## LONG ISLAND LIGHTING COMPANY

SHOREHAM NUCLEAR POWER STATION

SNRC-1424

Response to NRC Staff's Additional Questions  
Regarding LILCO's Proposed  
Supplemental Containment System  
Shoreham Nuclear Power Station - Unit 1  
Docket No. 50-322

FIGURE 1

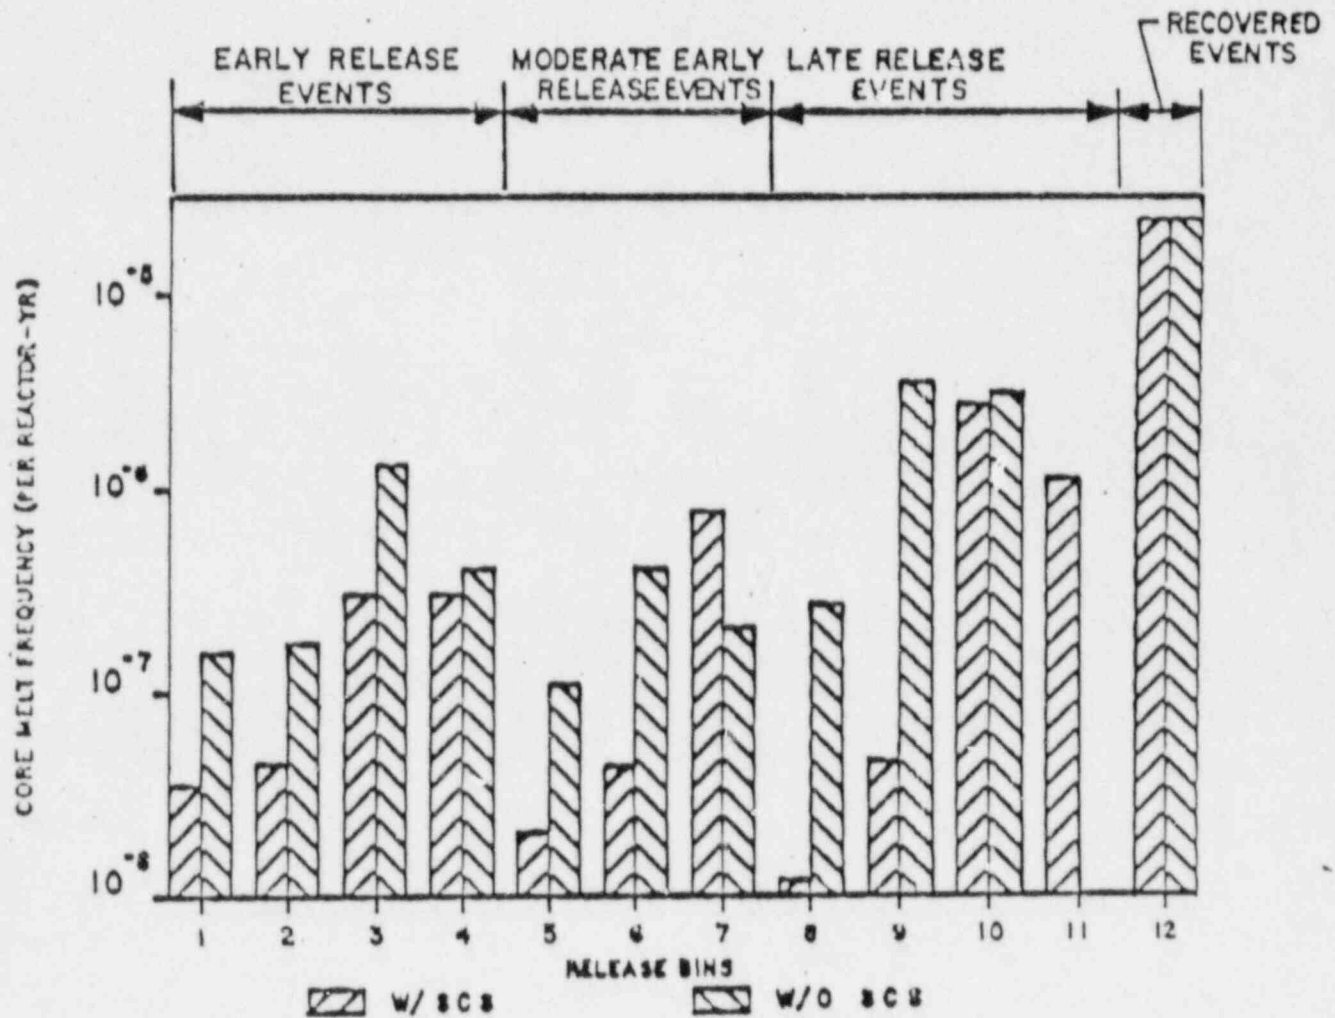
Question #3: Provide analyses on the releases from the SCS in new accident sequences where the containment is recoverable.

A comparison of the current PRA update results for the plant, both with and without SCS, show a shift in the accident frequency towards less severe accidents, and a similar positive shift in the release category frequency towards delayed and less severe releases. With regard to accident severity, containment venting through either the unfiltered vent flow path or SCS, primarily impacts the Class II and IV<sup>2/</sup> accident sequences. Class II accident sequences represent those accidents in which the buildup of decay heat in the containment induces high containment pressure and high suppression pool temperatures. Class IV accident sequences represent those accidents in which there is a failure to insert negative reactivity. The following table, which was developed as part of this current update, shows the contribution of each accident subclass to the total core melt frequency for the FILTRA (SCS) and containment vent (without SCS) cases. With the SCS, there is a shift in the relative significance of the accident subclasses from Class IIA to IIF and from Class IVA to IVF and IVG. This is significant because accident sequences in which there is a loss of containment decay heat removal which ultimately leads to containment failure, become a small part of the total core melt frequency, while accident sequences in which the containment remains intact and the releases are filtered become the major contributors to the total core melt frequency.

With regard to shifts in release category <sup>3/</sup> frequency, a similar comparison can be made. The following figure shows that there is a shift in the frequency of the early release categories (RC1-RC4) to categories RC-11 and RC-12, which are respectively characterized as filtered releases and events in which there is recovery of core cooling.
